Groundwater and Wastewater Services File Imaging Project

INDIVIDUAL WATER AND WASTEWATER SYSTEMS PROGRAM
APPLICATION FOR SERVICES

Re: Property located off Thayer Road
File: 653B/8524A
Parcel: 053-151-01

MECKLENBURG COUNTY ENVIRONMENTAL HEALTH
SITE EVALUATION REPORT
SERIAL NUMBER 12854

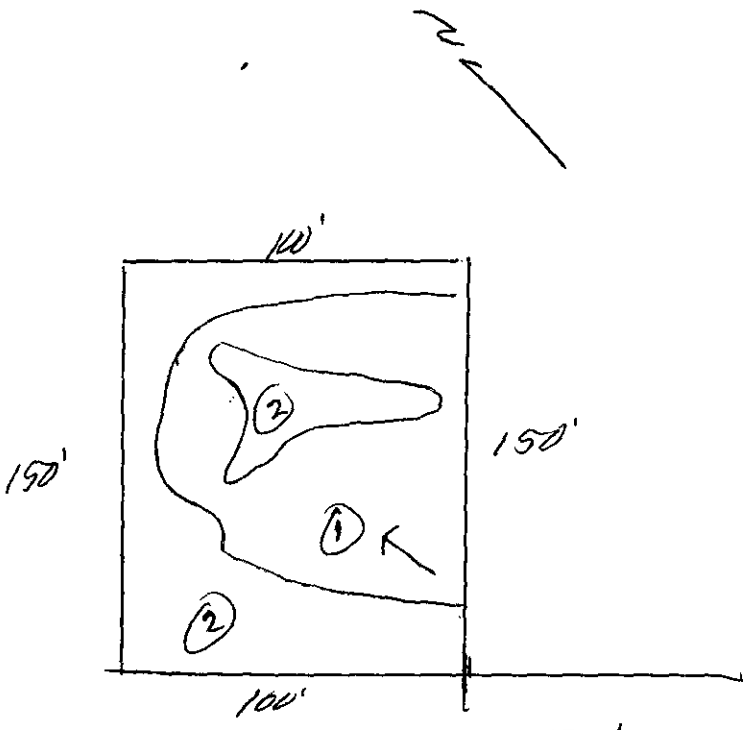
At your request, a field investigation was conducted on the property designated above for the purpose of determining site suitability for the installation of a ground absorption sewage disposal system. The results of this investigation showed the property to be classified **UNSUITABLE** for the installation of such a system. A copy of the site evaluation report (Serial No. 12854) is enclosed for your information.

Location: T Thayer Road
Subdivision:
Lot: Block: Acres: 3.5
Owner: Caren D. Hornbuckle
Address: 9240 T Thayer Rd
Charlotte, N.C. 28214
Comments: Surface and subsurface water must be diverted

FACTORS	AREA 1	AREA 2	AREA 3	AREA 4	AREA 5	AREA 6
Topography	S (PS) U 6-10%	S PS (U) complex slopes	S PS U	S PS U	S PS U	S PS U
Texture	S (PS) U slightly Expansive clay	S PS U —	S PS U	S PS U	S PS U	S PS U
Structure	S (PS) U sub-blocky	S PS U —	S PS U	S PS U	S PS U	S PS U
Drainage	S (PS) U 40" to water	S PS U —	S PS U	S PS U	S PS U	S PS U
Depth	S (PS) U 40"+	S PS U —	S PS U	S PS U	S PS U	S PS U
Restrictive Horizons	S (PS) U 40"	S PS U —	S PS U	S PS U	S PS U	S PS U
Available Space	S PS (U) Restricted	S PS U —	S PS U	S PS U	S PS U	S PS U
Other (specify)	S PS U	S PS U	S PS U	S PS U	S PS U	S PS U
Soil Group/Series	IV Cecil-Hilo	Complex Slopes				
Area Classification	S PS (U)	S PS (U)	S PS U	S PS U	S PS U	S PS U

State regulations provide that sites originally classified unsuitable may be utilized for the installation of alternate or modified sewage disposal systems provided the requirements of 15A NCAC 18A .1957 (c) are met. A reprint of this section is enclosed for your information.

Should you desire to file for permission to install an alternate or modified sewage treatment system on the property, please submit an Application for an Improvement Permit with an accurately dimensioned plot plan detailing the location of current and/or proposed buildings, wells and sewage disposal systems to this office. They will be reviewed, and if it is determined that the proposed system may reasonably be expected to function satisfactorily, an Improvement Permit will be issued by the Department upon completion by you, of a formal request for lot reclassification.
